**APPEAL STAFF REPORT - REVISED FINDINGS**

**Appeal number**.....A-3-SCO-02-117, Davenport Barn  
**Applicant**.....David Luers  
**Appellants**.....Commissioners Sara Wan and Pedro Nava; Sierra Club; Coastal Organizers and Advocates for Small Towns (COAST)

**Project description**.....Demolish a deteriorated barn, remove a 5-foot diameter and approximately 70-foot tall eucalyptus tree, and construct a 3-story, roughly 6,400 square foot structure (4,316 square feet of enclosed interior space and 2,084 square feet of wrap-around decks/walkways) that would include two residential units and a retail sales operation (the project is roughly half residential and half retail), with an approximately 4,700 square foot 10-car parking lot and associated hardscape (patios and paths) and landscaping.

Storm Drainage Areas  
DWG 1

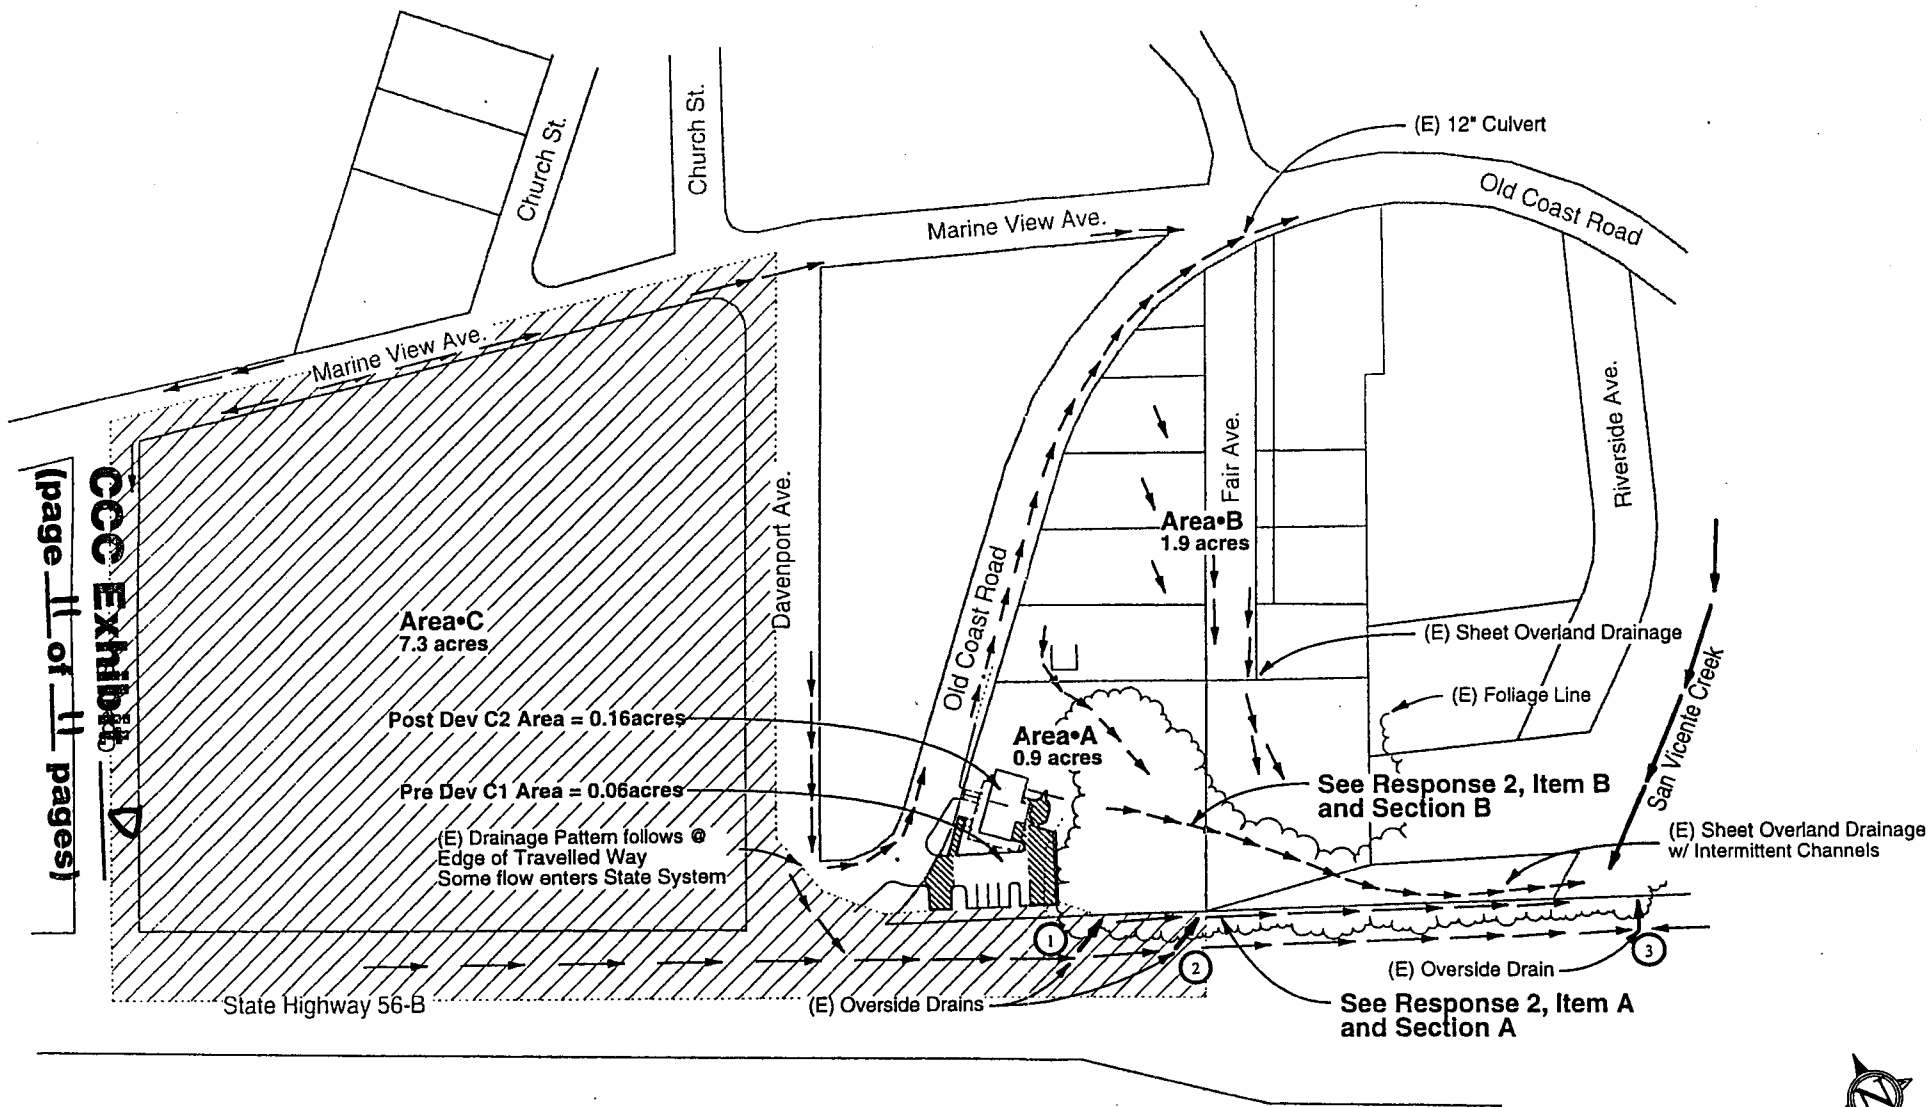
The standard silt and grease trap proposed would act as small sediment and runoff holding basin, but is incapable of filtering and treating runoff to remove typical urban runoff pollutants. Although the trap proposed would perform a gross filtering function, the runoff that would exit from the trap would still be expected to contain pollutants of concern.<sup>34</sup> This partially filtered runoff would be directed to the riparian corridor below, where additional pollutants would settle out, and would ultimately make its way to San Vicente Creek and on to the Pacific Ocean.

ensure that: all site drainage features and/or structures (e.g., pipes) are confined within the disturbance area and are prohibited in the riparian woodland and its setback area; post-development peak runoff rates and volumes are maintained at levels similar to, or less than, pre-development conditions; all runoff is filtered and treated prior to its use for on-site irrigation or infiltration, or its discharge off-site; all vehicular traffic and parking areas on site are swept and/or vacuumed at regular intervals (and before and after the rainy season); spill response materials are maintained on-site; and all drainage system elements are permanently operated and maintained (see special condition 1).

SE ELEVATION - TRAVELING NORTH ON HIGHWAY 1, ENTERING DAVENPORT

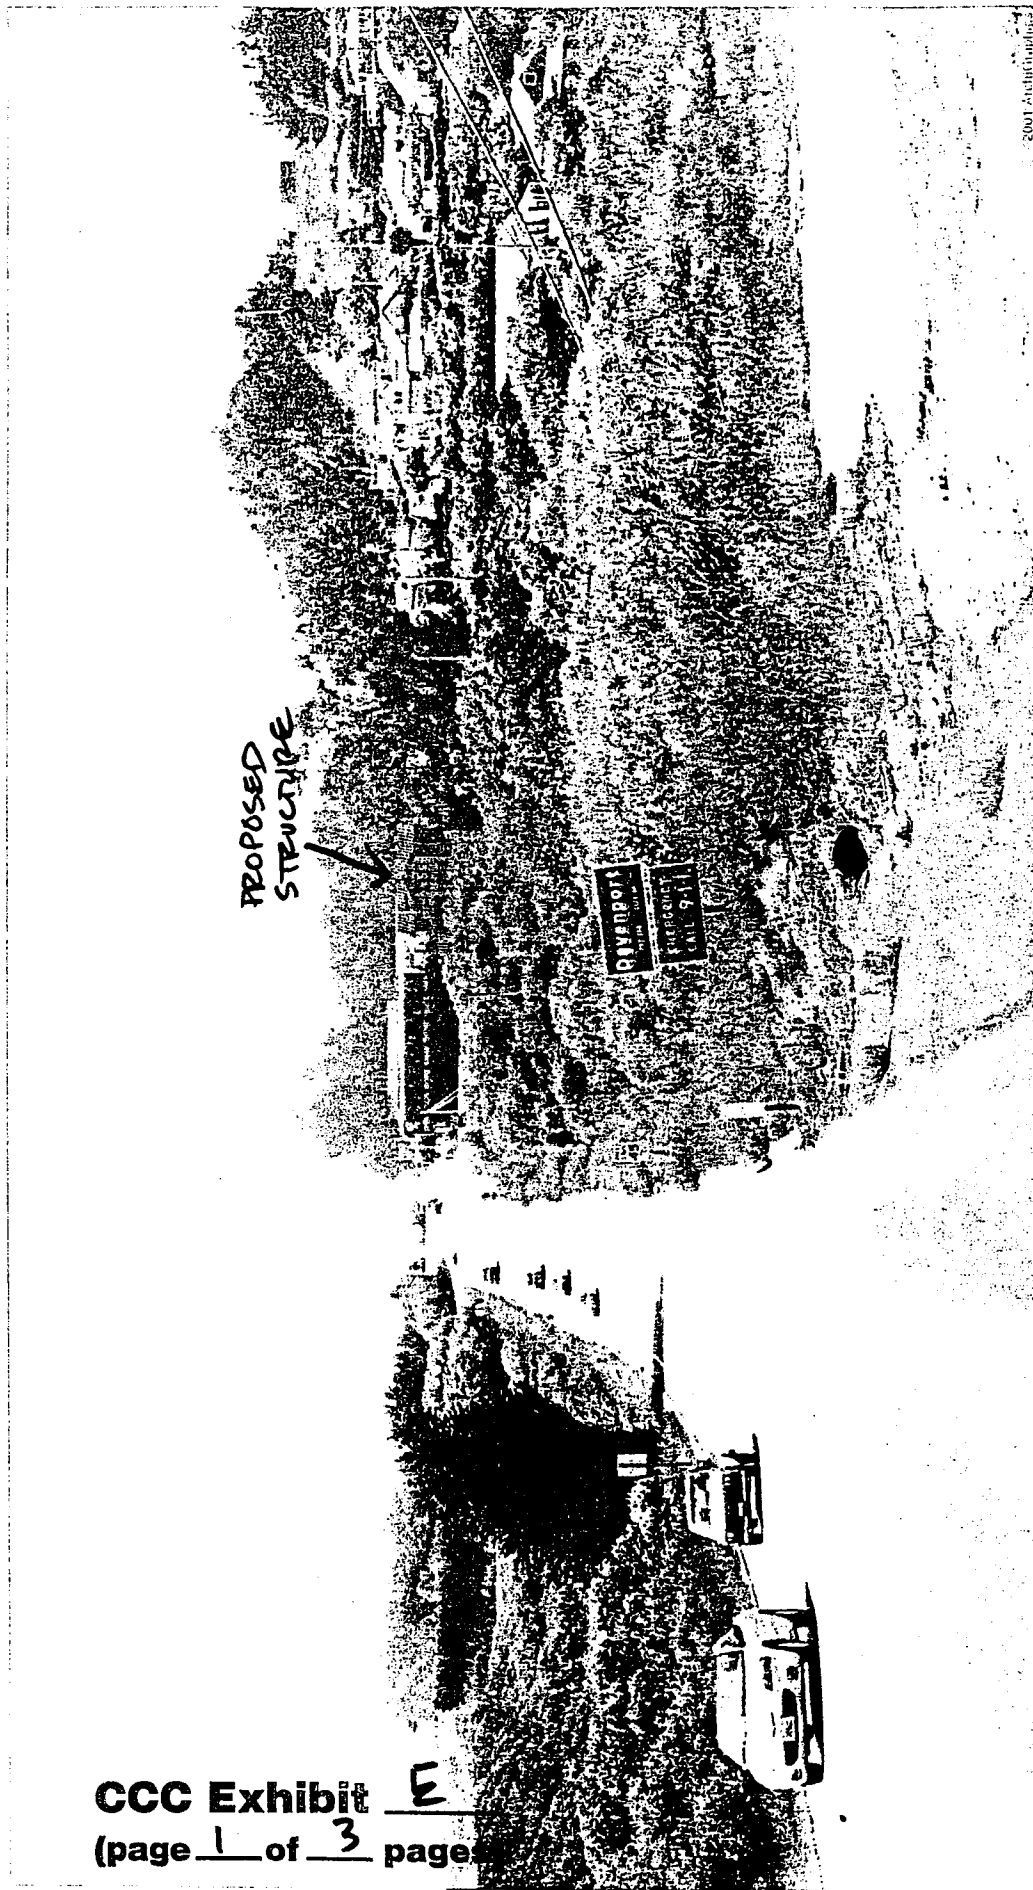
<sup>24</sup> Again, there has been confusion on the overall height proposed. The proposed project plans show the height to be in excess of 35 feet, with a maximum grade to pitch height of 37 feet (see approved plans in exhibit D). In the time since this item was appealed, the County subsequently indicated that the Applicant agreed to lower the height 32.4 feet; that this lower height is what is shown on the project flagging, staking, and photo simulations (see exhibits C and E); that it was the lower height that was reported to the Planning Commission when they approved the project; and that although there was no written condition or requirement, that the County would enforce the lower height through their coastal permit (personal communication from County planning staff). At the Commission's June 11, 2003 hearing, the Applicant indicated that the maximum height proposed is 32.4 feet.

- (c) **Building Height.** The building shall not exceed 32.4 feet in height in any location as measured from existing or finished grade, whichever is lower. The plans shall identify existing and finished grade in each elevation, along with a line depicting 32.4 feet above each where the 32.4 foot line mimics the contour of existing and finished grade.
